Montana State University
Brick Breeden Fieldhouse Locker Room 116 Renovation
Bozeman, Montana 59717

ADDENDUM #1
This addendum consists of: 1 pages

Subject: MSU Brick Breeden Fieldhouse Lock Room 116 Renovation
Job Number: 22057.01 PPA #21-0028

CONSTRUCTION DOCUMENTS

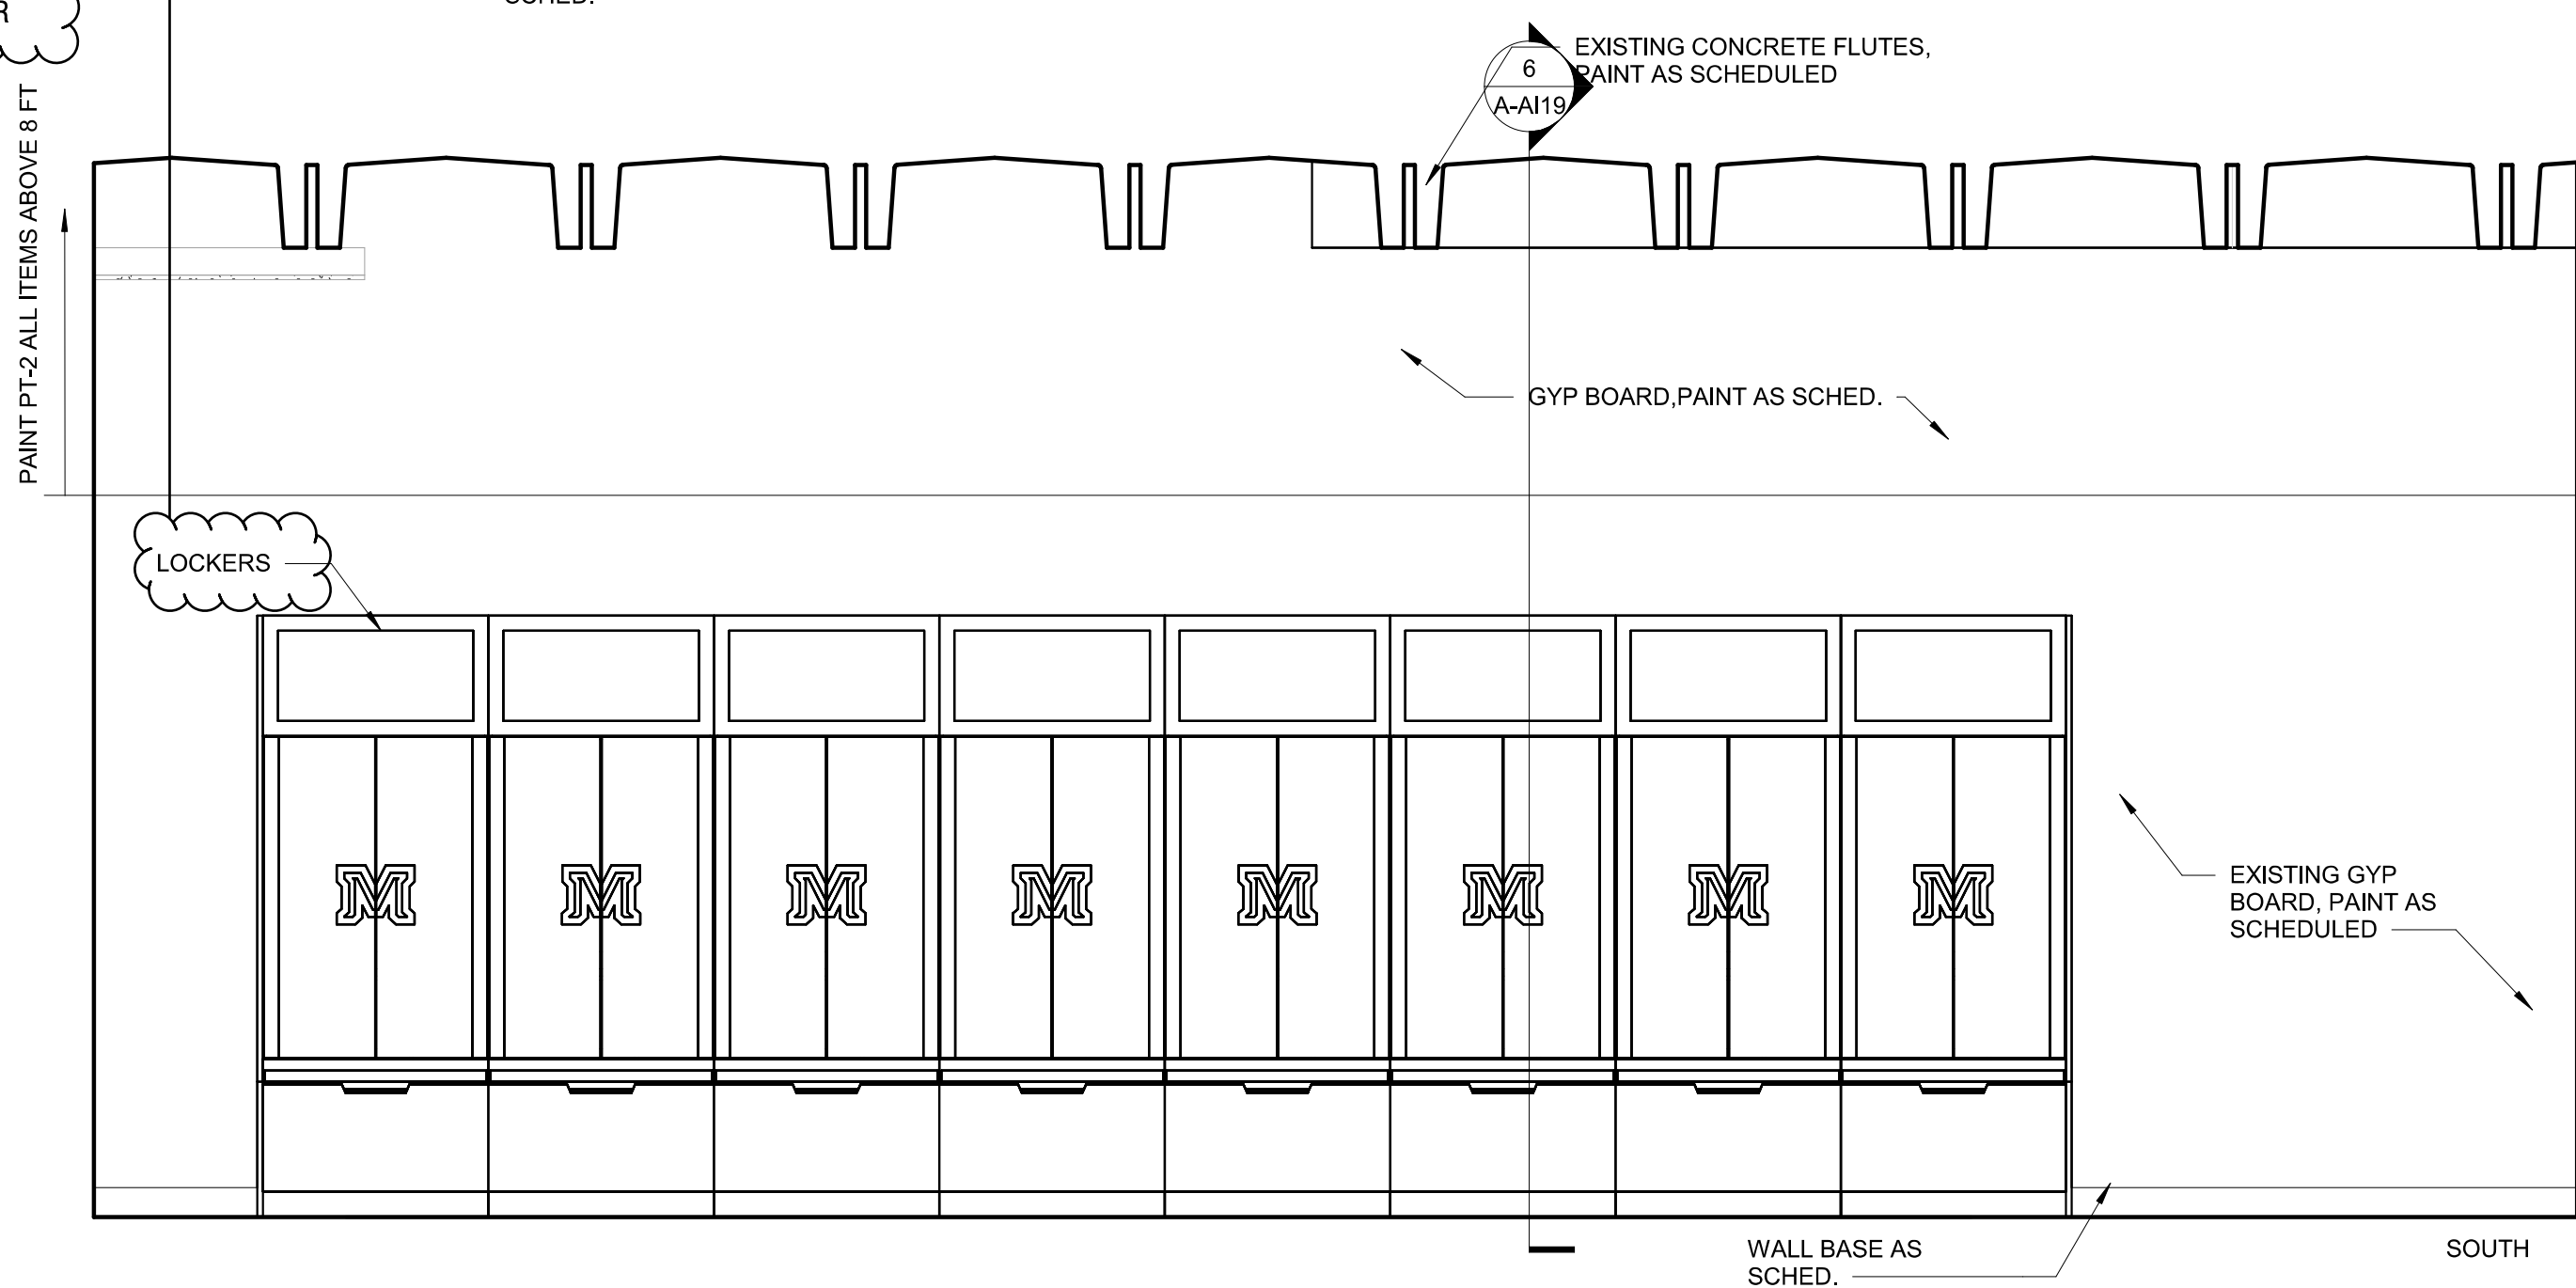
LOCKERS TO BE FURNISHED BY OWNER, INSTALLED BY CONTRACTOR

SHEET
A-A114

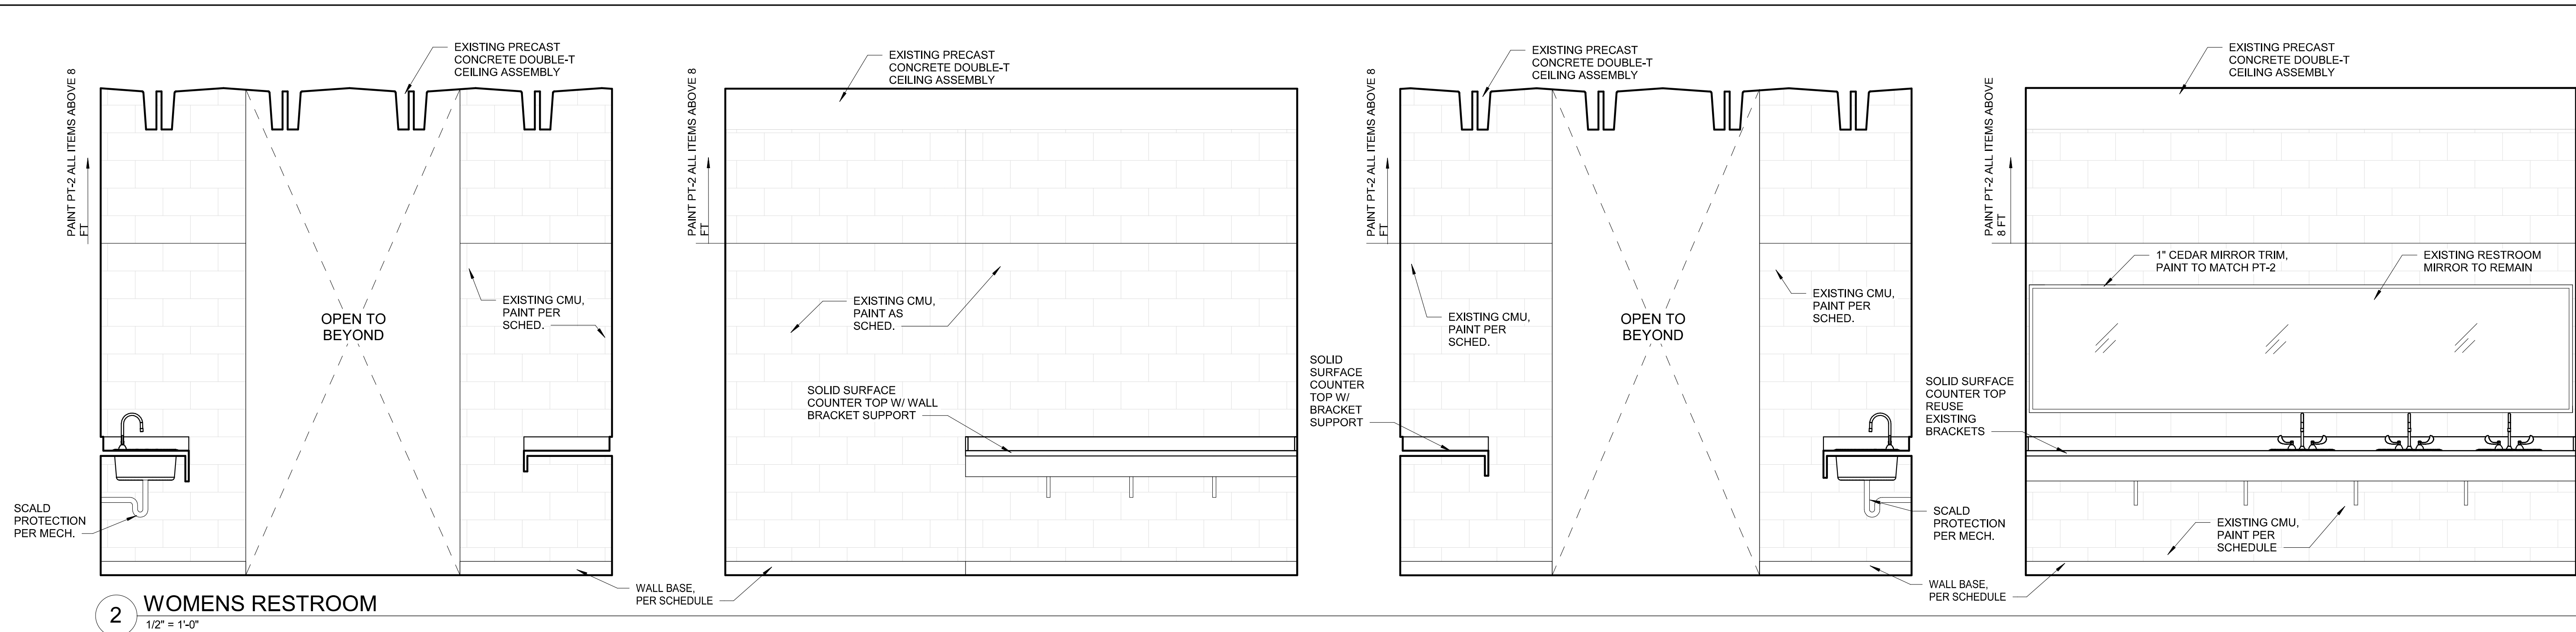
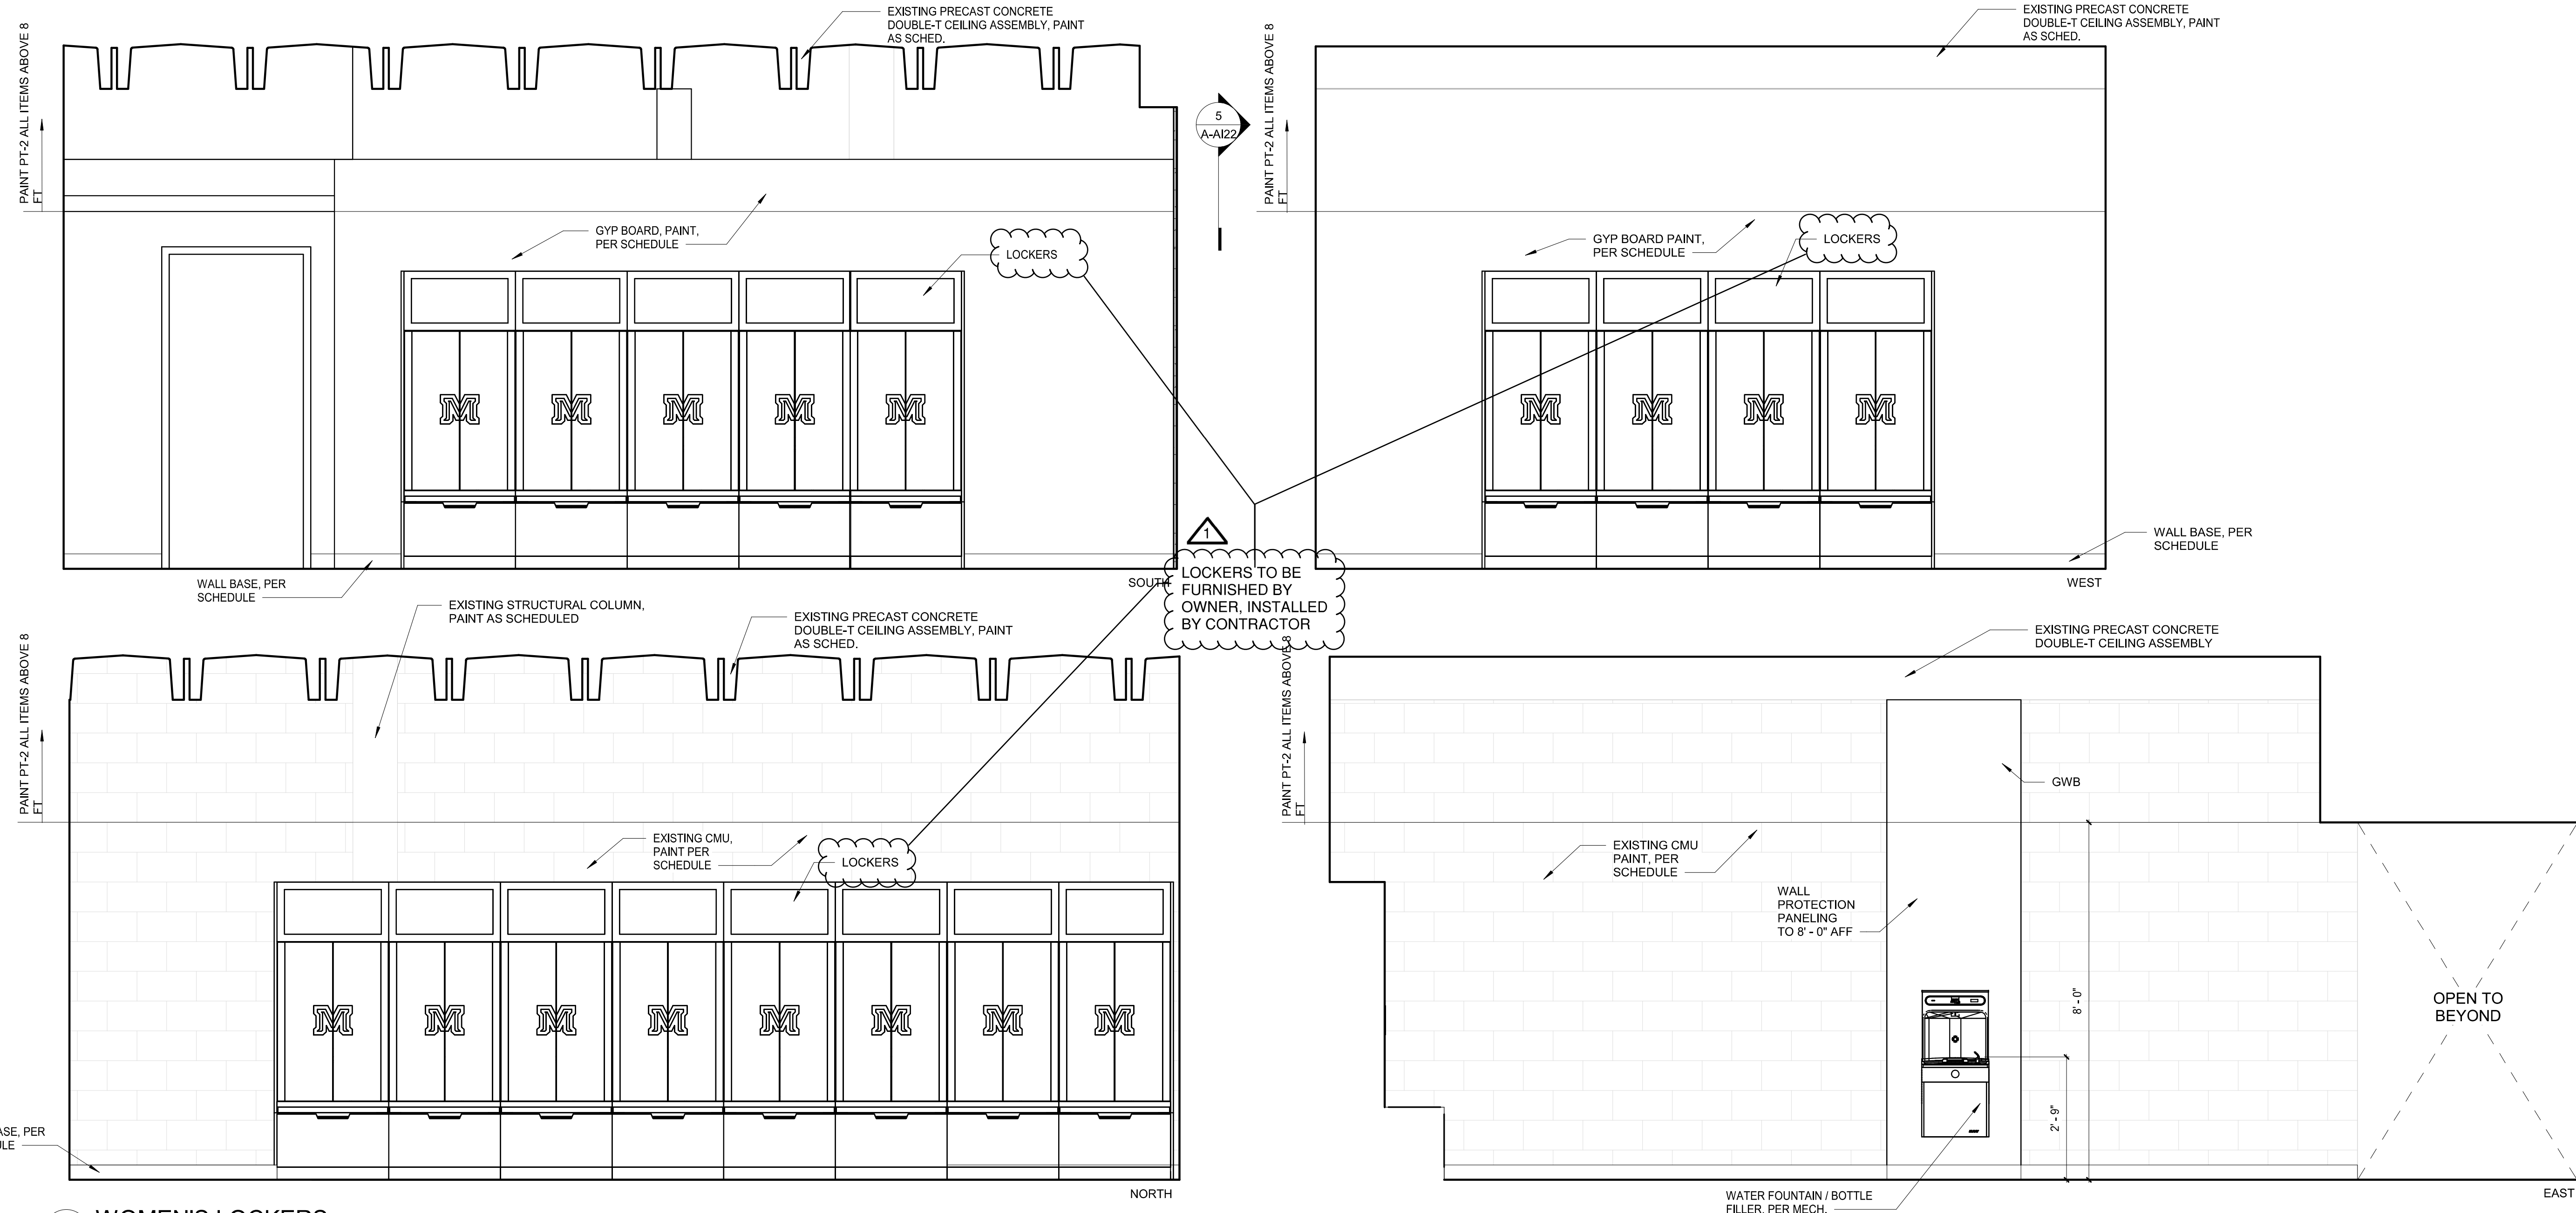
1. Sheets A-AI10, A-AI12, A-AI14
a. Reference to Lockers added: LOCKERS TO BE FURNISHED BY OWNER, INSTALLED BY CONTRACTOR
- Item 5: Bidders Questions:
1. Is there an anticipated Start Date and Anticipated Completion Date?
